ELEVATION C
2670
SQUARE FEET

CONSTRUCTION SUMMARY

Grovetrail Developments Inc.

LOT NUMBER	PHASE	HOUSE TYPE	CLOSING DATE
42	1	BELVEDEERE Elev C	08-Mar-22

FRONT ELEVATION 'C'

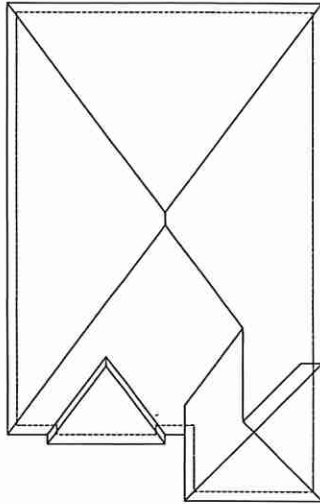
* Install Ten (10)
Exterior Pot Lights w/
1 switch
